Re: Rapiscan AIT System Radiation Survey Reporting

Rapiscan by SPECTRA	Secure 1000 Radiation Emission Measurement	FORM R-0646-1 (Single Pose)
-------------------------------	---	--------------------------------

**R-0646-1 Addendum
(Documentation Errors)**

Product Name	Secure 1000SP (Single Pose)
Serial Number	S51013010
Radiation Emission Measurement	Radiation Survey Dated: 09/24/2010
RSO Initials

Side View

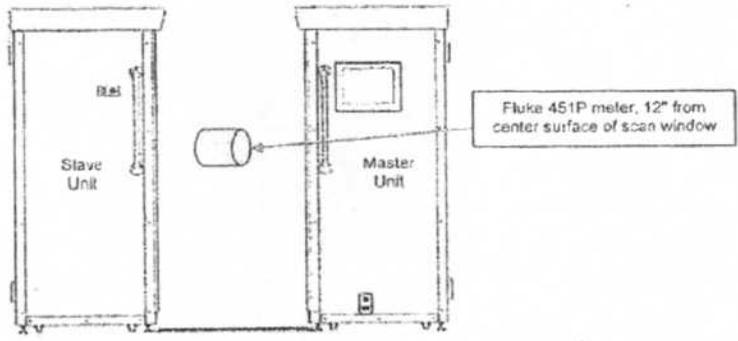
1. No value indicated for background radiation. Typical values range from 7uRem/hr to 13uRem/hr at sea level. Note: Absence of value has no adverse impact on calculations.
2. TABLE 1: Incorrect presentation of data in Column 3 for Measured Exposure. Indicated values are 40uR and 33uR. Corrected values are 4.0uR and 3.3uR
3. TABLE 1: Incorrect presentation of data in Column 6 for Effective Dose. Indicated values are 23 uRem and 18 uRem. Corrected values are 2.3 uRem and 1.8 uRem.
4. Technician did not initial pass or fail check box.
5. Technician did not print his name.

The service technician should attend refresher training.

The corrected data indicates this system was operating within expected parameters. No re-survey is required for this system.
